On behalf of the Department of Energy/National Nuclear Security Administration (DOE/NNSA) and Sandia Corporation (Sandia), DOE/NNSA is submitting Responses to the New Mexico Environment Department's (NMED) Comments in "*Notice of Disapproval: Response to the Notice of Disapproval for the Tijeras Arroyo Groundwater Investigation Report, February 2009, Sandia National Laboratories, EPA ID NM5890110518, SNL-05-028.*"

**U.S. Department of Energy's/Sandia Corporation's Responses
to the New Mexico Environment Department's Comments
in
"Notice of Disapproval: Response to the Notice of Disapproval for the
Tijeras Arroyo Groundwater Investigation Report, February 2009
Sandia National Laboratories
EPA ID# NM5890110518 SNL-05-028"**

This document responds to the comments received in a Notice of Disapproval (NOD) letter from the New Mexico Environment Department (NMED) to the U.S. Department of Energy (DOE) and Sandia Corporation (Sandia) on August 12th, 2009 regarding the response to the August 2008 NOD on the current conceptual model of groundwater hydrology and contaminant distribution in the Tijeras Arroyo Groundwater (TAG) study area in the vicinity of Technical Area I, II, and IV at San

- Replacement Page 3-3 (revised Figure 3.1.3-1)

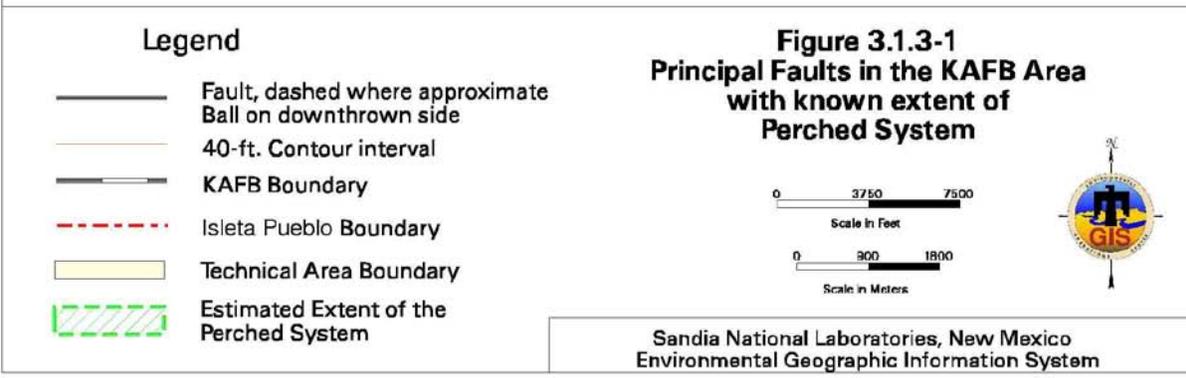
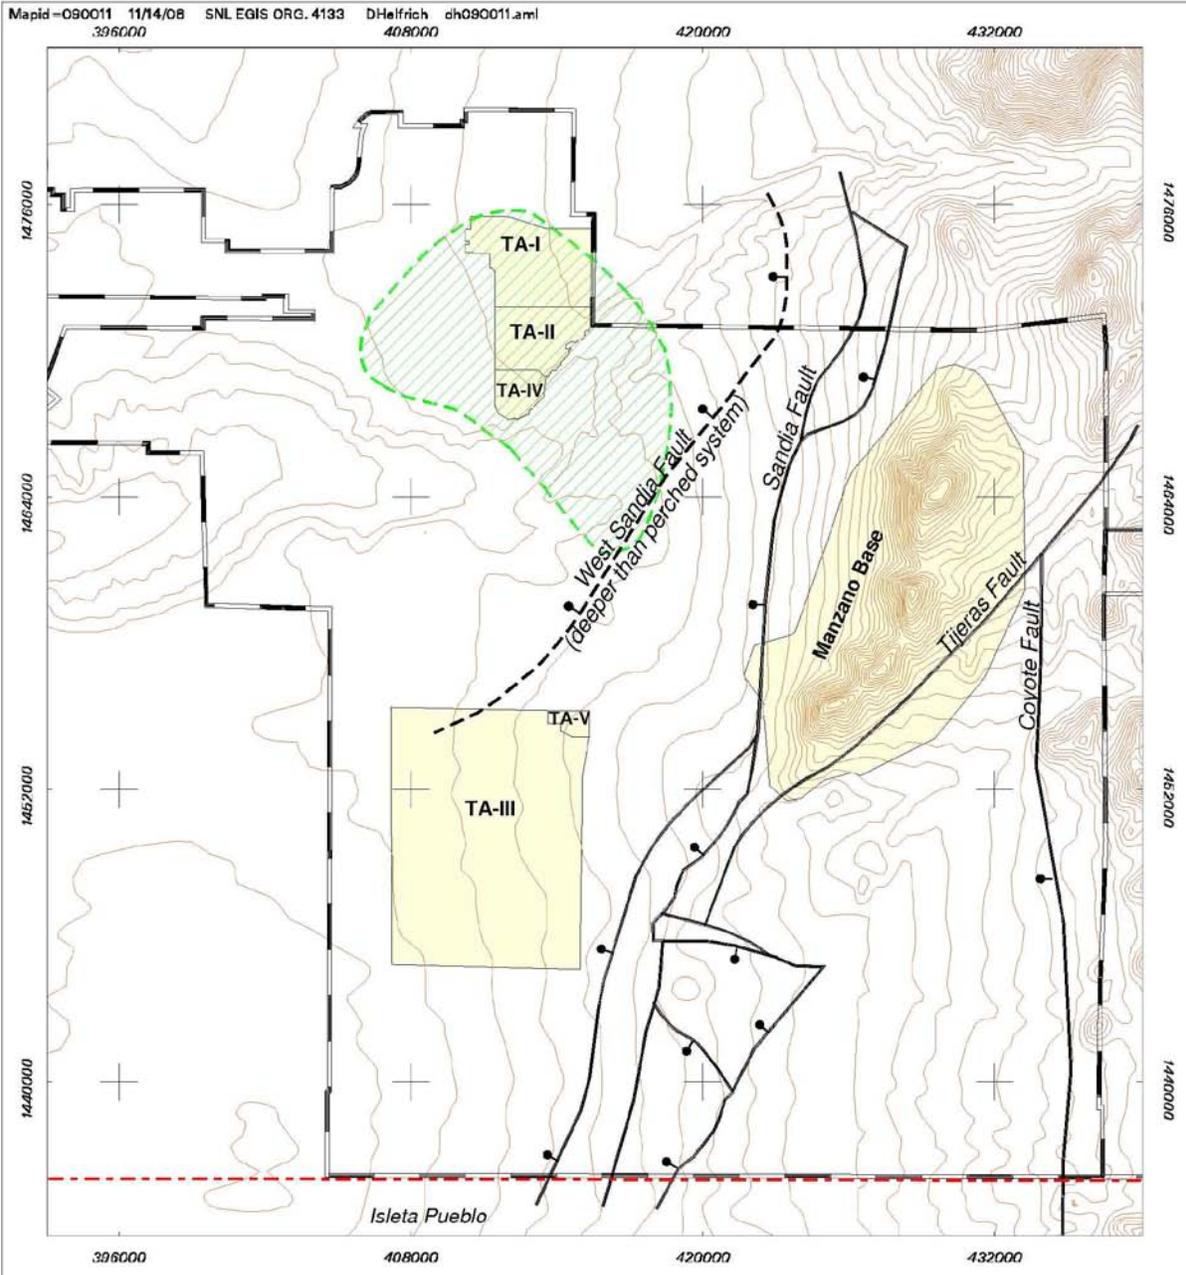
3. Specific Comment #20: Section 3.1.3.2, page 3-3, Figure 3.1.3-1

In process of revising Figure 3.1.3-1, the labels for the West Sandia Fault, the Sandia Fault, the Tijeras Fault, and Manzano Base were removed. Additionally, the boundary line between southern Albuquerque and northern Isleta Pueblo is absent suggesting that Isleta Pueblo land abuts the western side of Kirtland Air Force Base (KAFB), where McCormick Ranch is actually located. To maintain consistency with TAG IR Section 3.1.3.2 and TAG IR Figure 3.3.5-2, the Permittees must modify revised Figure 3.1.3-1, as follows:

- **Add a label for the West Sandia Fault and restore the phrase "deeper than perched system."**
- **Revise the West Sandia Fault line to reflect that its location is approximate.**
- **Add a label for the Sandia Fault.**
- **Add a label for the Tijeras Fault.**
- **Add a label for the Coyote Fault.**
- **Add a label for the Manzano Base.**
- **Extend the Isleta Pueblo boundary line to the west.**

The Permittees must submit the revised figure to the NMED.

Response: The suggested changes have been made to Figure 3.1.3-1, and the revised figure is provided in Appendix B.

- Revised Figure Q-1. Tijeras Arroyo Groundwater Investigation Potentiometric Surface Map for the Regional Aquifer (December 2008/March 2009)
- Revised Figure R-1. Tijeras Arroyo Groundwater Investigation Potentiometric Surface Map for the Perched Aquifer (December 2008/March 2009)

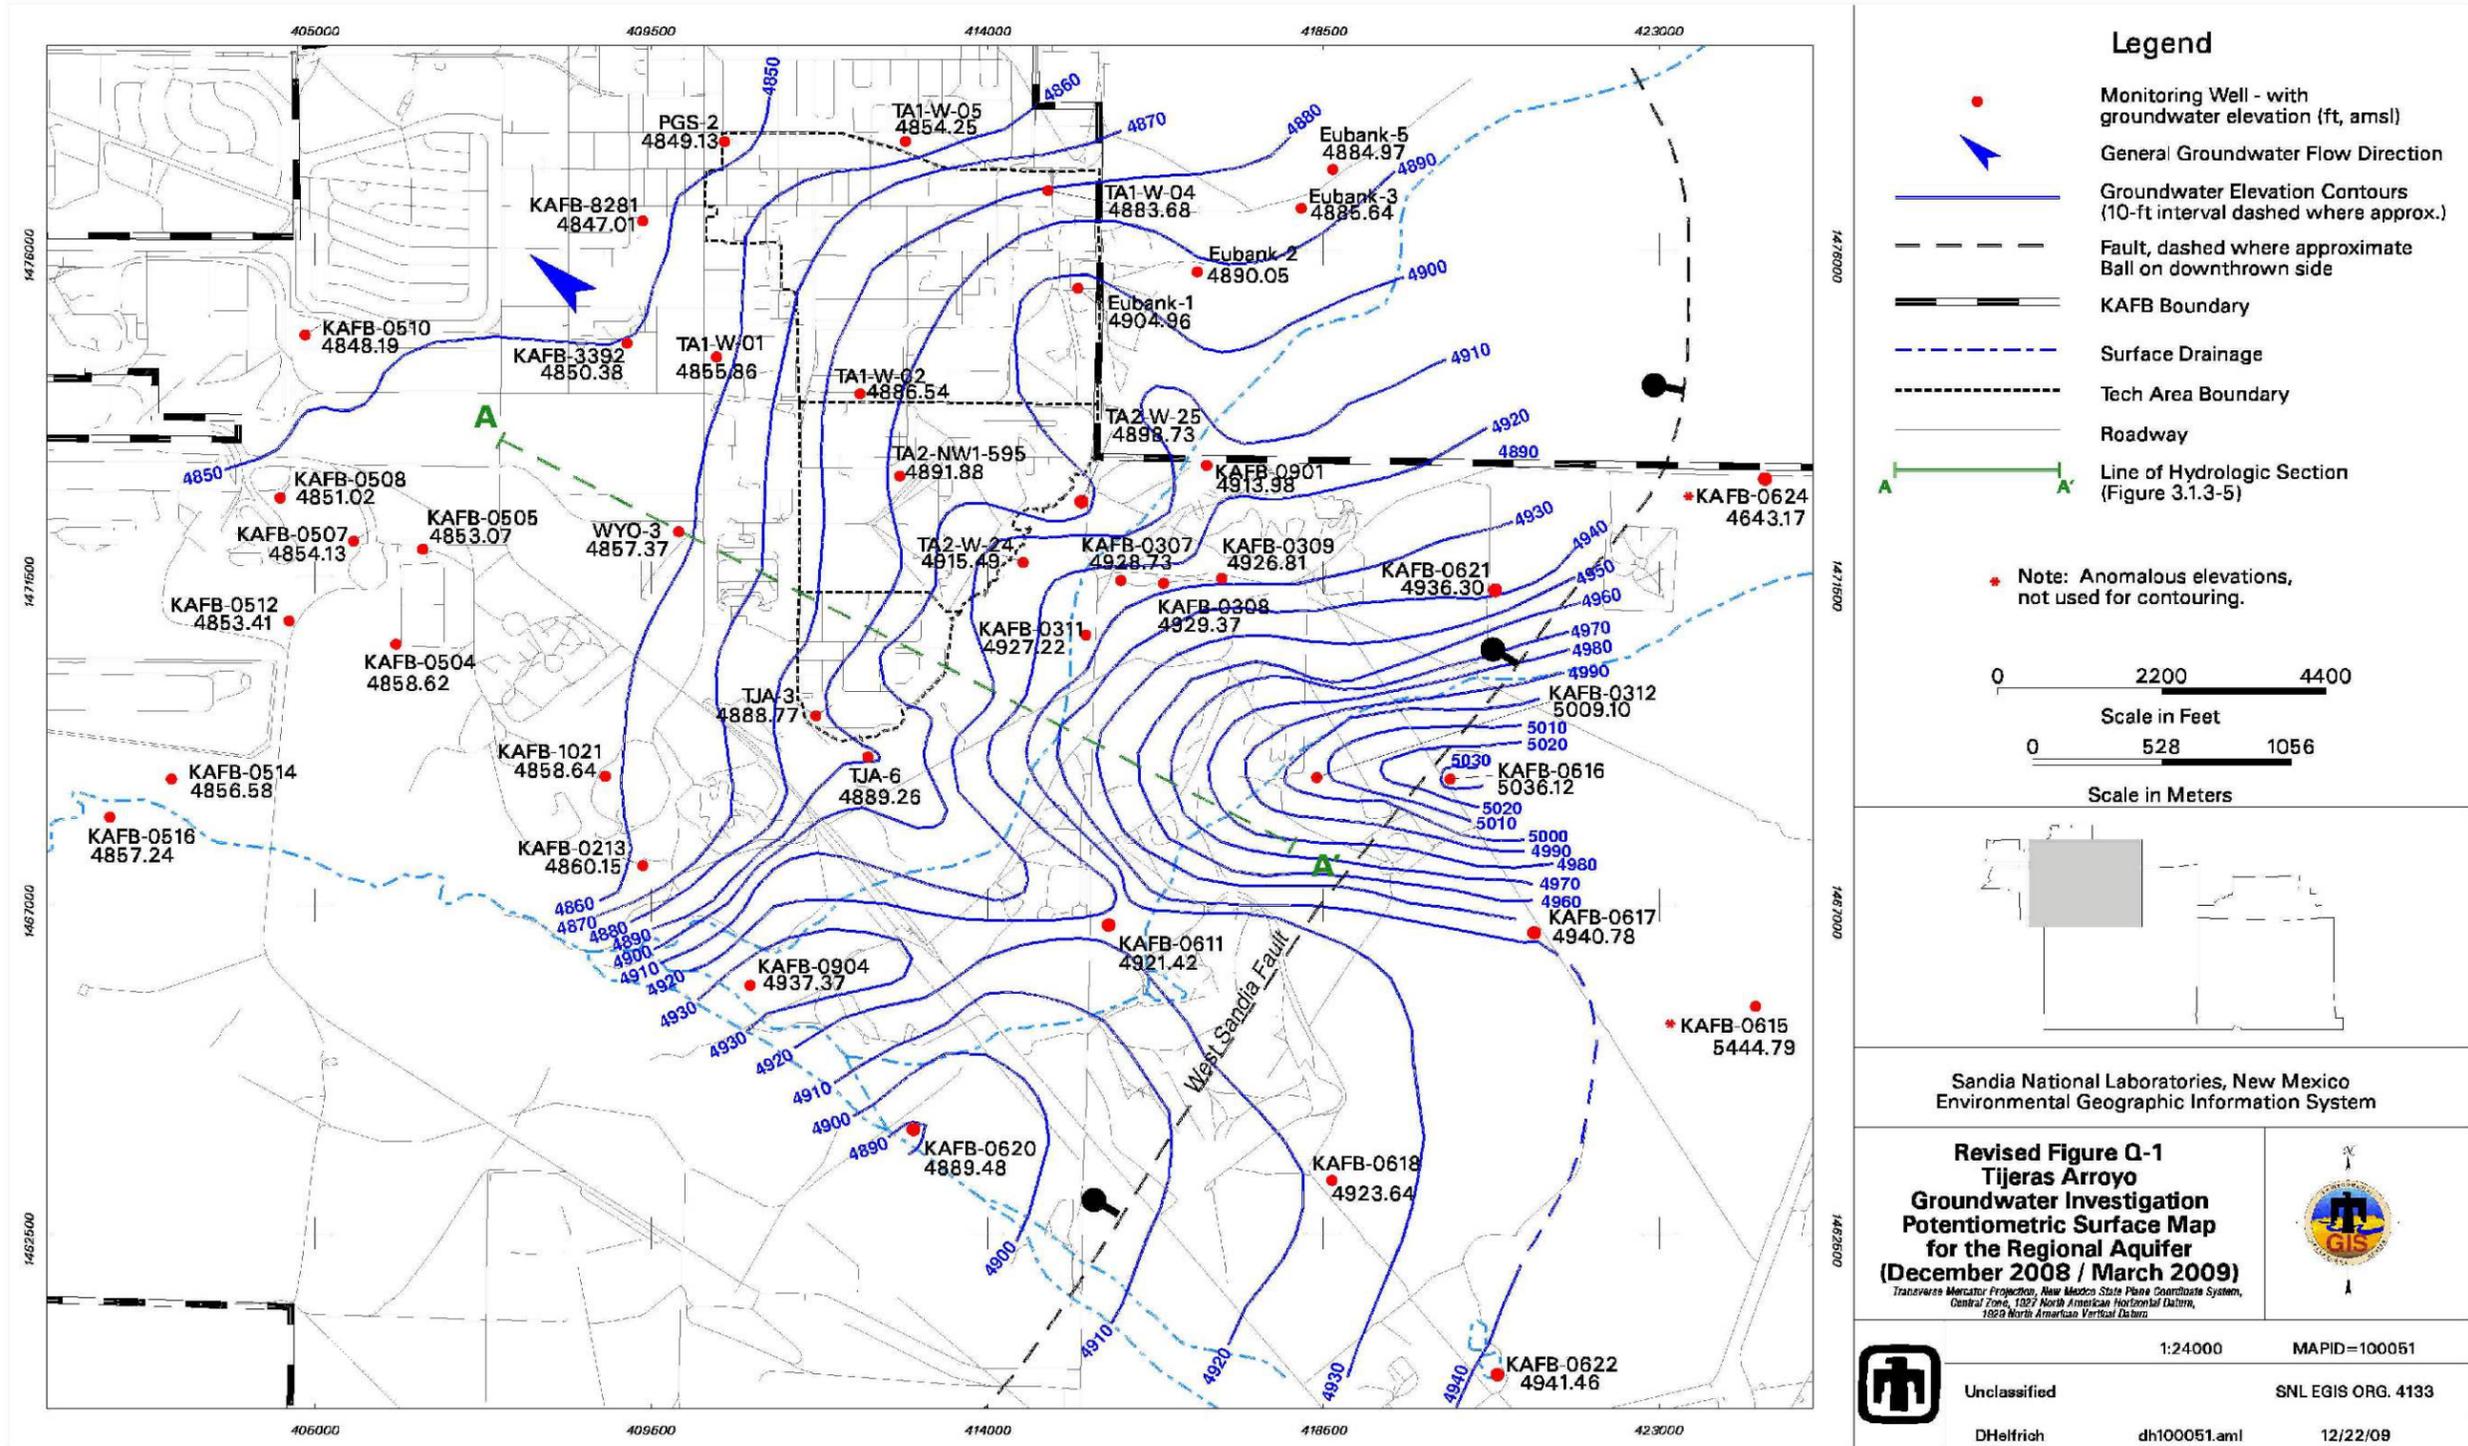
4. Specific Comment #22: Section 3.1.3.3, page 3-7, Figure 3.1.3-3 and Section 3.3.4.1, page 3-20, 1st paragraph, last two sentences

In the first NOD dated August 1, 2008, NMED requested in Specific Comments #22 and #23 that the Permittees submit new potentiometric surface maps for the regional and perched aquifers using concurrent contemporaneous water levels newly obtained for the TAG wells. NMED also requested that the new maps depict those wells that were excluded due to "anomalous" groundwater elevations.

The Permittees provided new maps, in response to Specific Comments #22 and #23 of the August 1, 2008 NOD. Examination of the new maps raises new questions:

- In the written response to both Specific Comment #22 [sic], the Permittees indicated that one regional well (KAFB-0615) was not used for contouring because its water level elevation significantly differs from surrounding wells. The Permittees explain that the anomaly may be due to the West Sandia Fault, which lies between the excluded regional well (KAFB-0615) and the nearest TAG monitoring well (KAFB-0616), possibly affecting regional water levels. However, the map does not show the West Sandia Fault.

- The submitted figures remain limited to wells designated for TAG despite the existence of additional surrounding monitoring wells that may further understanding of the groundwater systems. For example, different configurations of the regional, perched, and intermediate or merging aquifer systems are evident upon inclusion of water level data from eleven KAFB wells (KAFB-0611, KAFB-0612, KAFB-0613, KAFB-0617, KAFB-0618, KAFB-0619, KAFB-0620, KAFB-0621, KAFB-0622, KAFB-0623, and KAFB-0624). While these eleven wells are not specifically TAG wells, their proximity to TAG wells makes them useful for defining the groundwater systems. Inclusion of these wells will require cooperation using the negotiated agreements of the TAG High Performing Team (HPT).

To further the understanding of the groundwater aquifer systems, the Permittees must revise the water table maps for the regional and perched aquifers. The revisions must include:

- The West Sandia Fault;
- The eleven additional KAFB wells ((KAFB-0611, KAFB-0612, KAFB-0613, KAFB-0617, KAFB-0618, KAFB-0619, KAFB-0620, KAFB-0621, KAFB-0622, KAFB-0623, and KAFB-0624); and
- Reinterpretation of all groundwater systems, as necessary.

Response to Issue # 1: The potentiometric surface maps have been revised to include groundwater elevation data from the eleven non-TAG High Performing Team (HPT) groundwater wells, and the groundwater systems have been reinterpreted, as necessary. Per Comment 1, the groundwater elevations presented in Revised Table A-1 (Appendix A) were used to prepare revised Figures Q-1 and R-1 (Appendix C). These maps were constructed based on December 2008 water level measurements from the 63 existing TAG HPT monitoring network wells, and also include March 2009 water level measurements from the eleven non-TAG HPT wells.

For the regional aquifer map (revised Figure Q-1), although wells KAFB-0615 and KAFB-0624 are completed in the regional aquifer they were not used for potentiometric surface contouring. As seen on revised Figure Q-1, these wells have anomalous groundwater elevations that were very different than those in surrounding wells. The groundwater elevation in KAFB-0615 is over 500 ft higher than those in the two nearest adjacent monitoring wells (KAFB-0617 and KAFB-0618). The groundwater elevation in KAFB-0615 is believed to represent groundwater conditions that are localized near the Manzanita Mountain front, and that are not representative of the typical regional aquifer in the TAG study area. The groundwater elevation in KAFB-0624 is approximately 300 to 400 ft lower than those in the two nearest adjacent wells (KAFB-0621 and KAFB-0616). The groundwater elevation in KAFB-0624 is believed to be influenced by groundwater withdrawal at City of Albuquerque production well 4Hills-1 approximately 1 mile to the north-northeast.

Well TJA-4 was not used for potentiometric surface contouring for either the perched or regional aquifer maps. The groundwater elevation at TJA-4 is approximately 35 ft lower than the nearest perched aquifer well (TJA-5), and approximately 100 to 150 ft higher than those in the two nearest adjacent monitoring wells (KAFB-0311 and TJA-6). The groundwater elevation in TJA-4 is believed to represent a localized water-bearing zone between the perched system and regional aquifer, in the area where the two aquifers merge.

**Revised Figure R-1
Tijeras Arroyo
Groundwater Investigation
Potentiometric Surface Map
for the Perched System
(December 2008 / March 2009)**

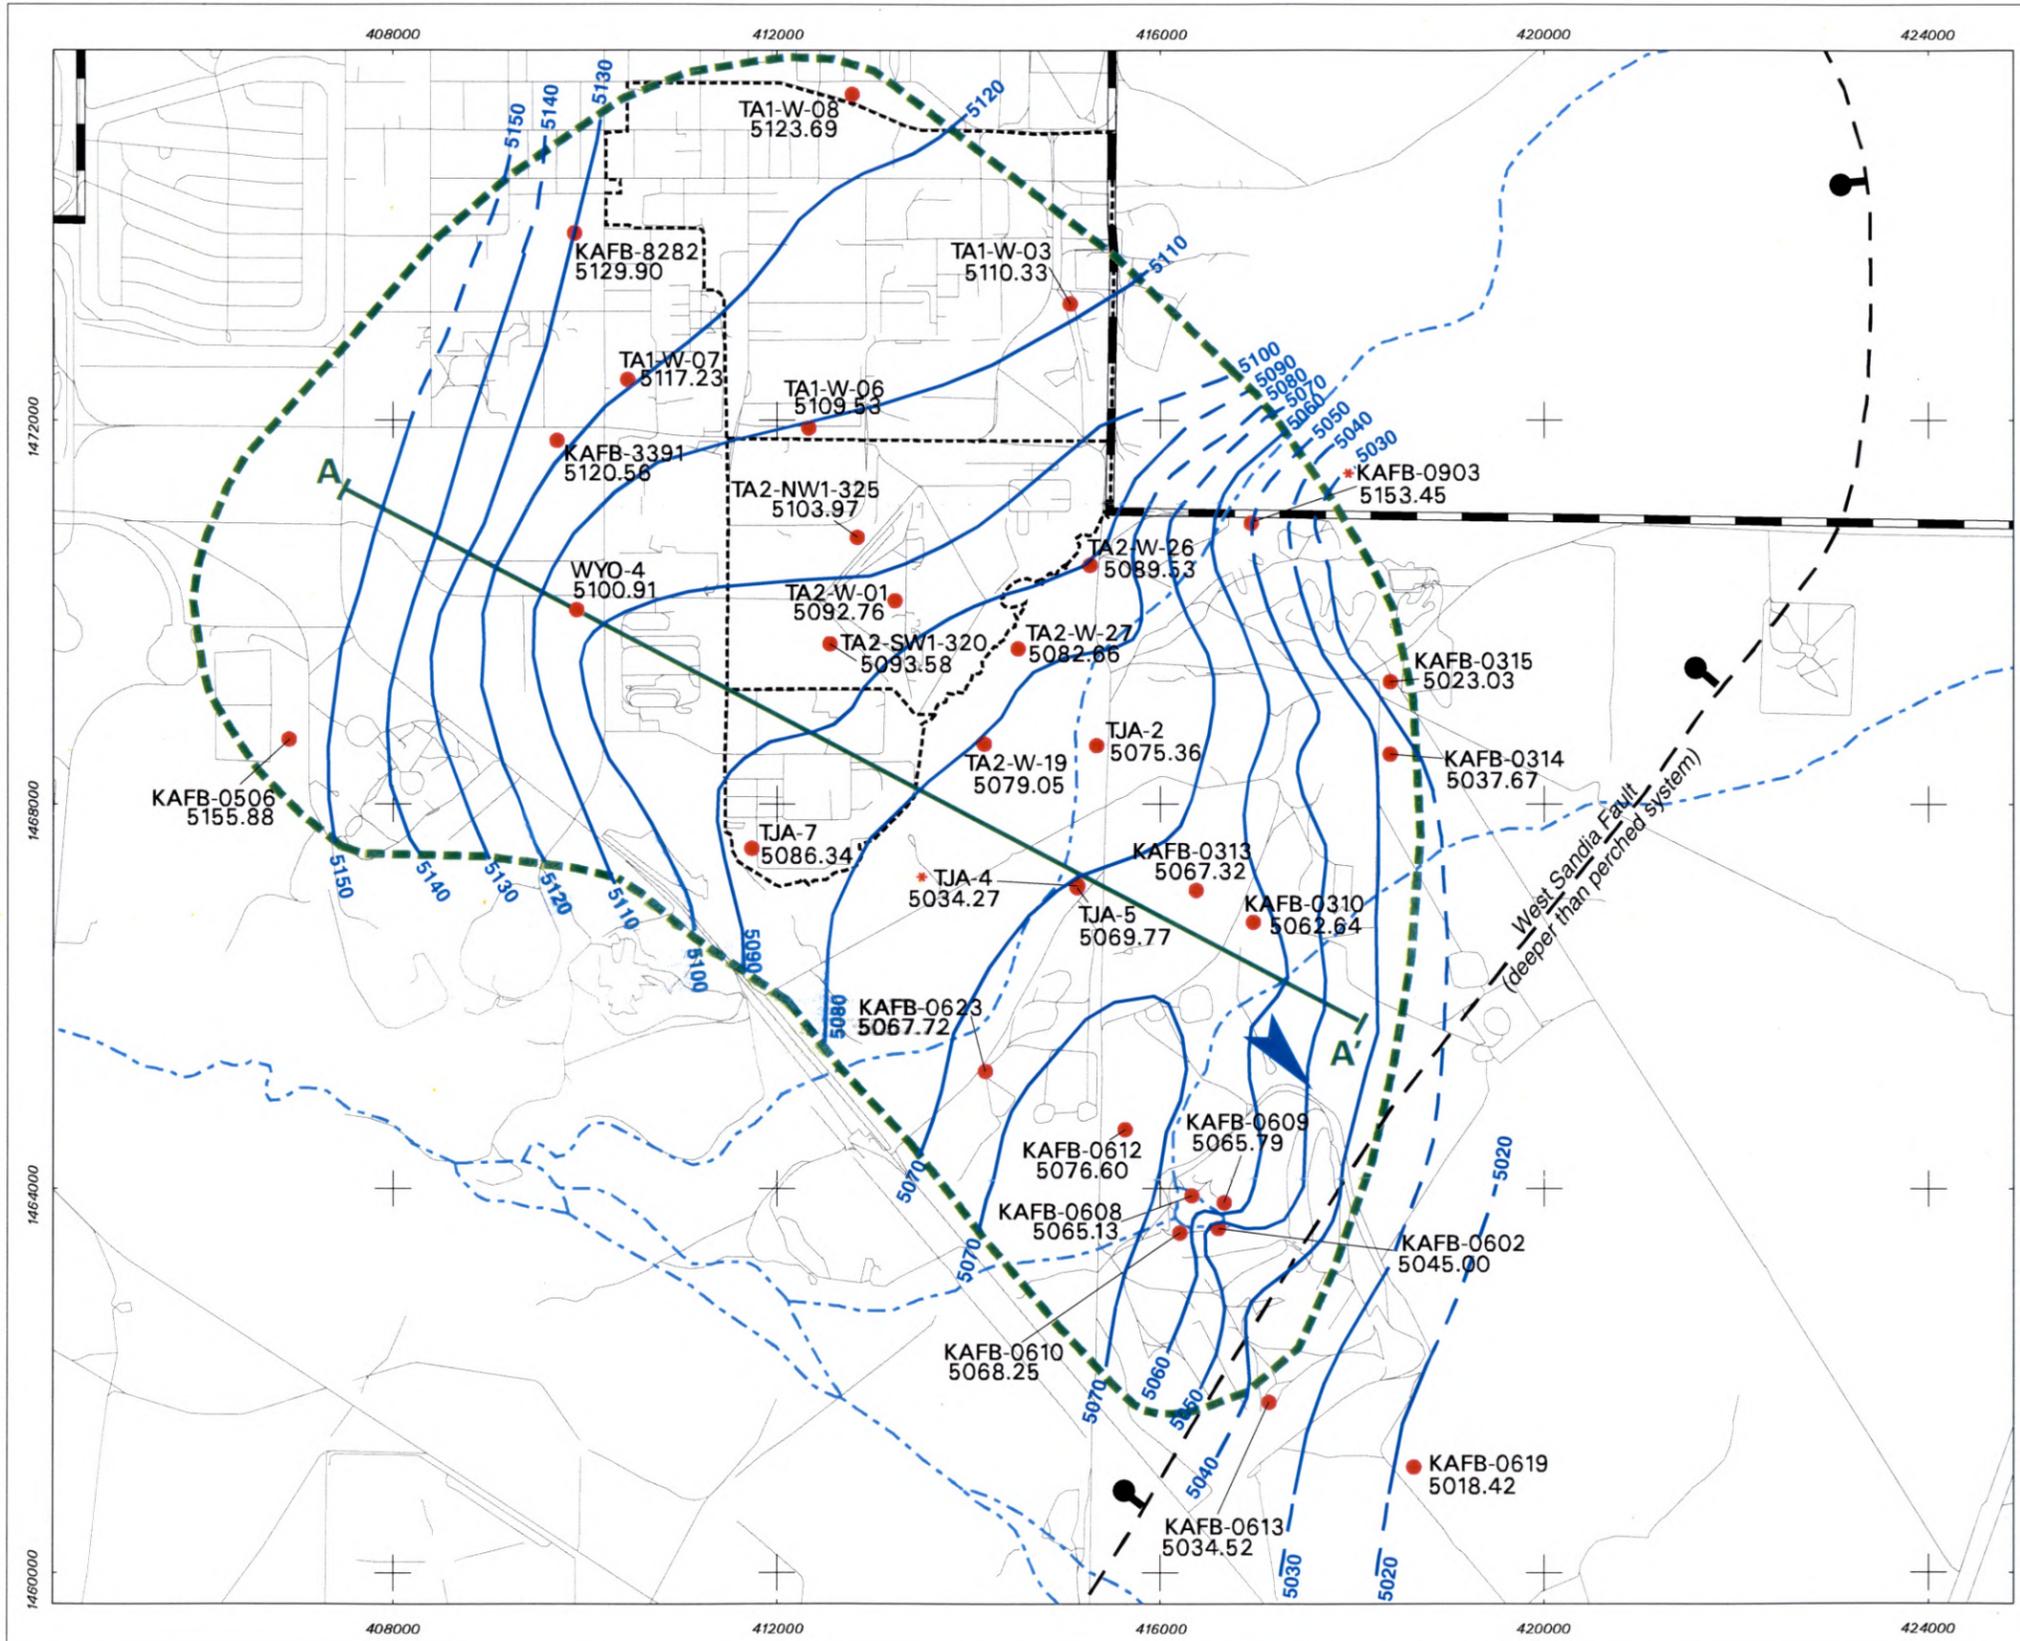
Specific Comment #23: Section 3.1.3.3, page 3-8, Figure 3.1.3-4

The Permittees must resubmit all figures to the NMED.

As described in the response to the first NOD (SNL/NM February 2009), the designation of the aquifer system is, at times, ambiguous. This is due to the very complex hydrogeologic system in the study area and the evolution of the conceptual model over time by numerous workers at a variety of agencies. The designations of the aquifer system presented in the revised potentiometric surface maps Q-1 and R-1 (Appendix C), as well as Revised Table B-
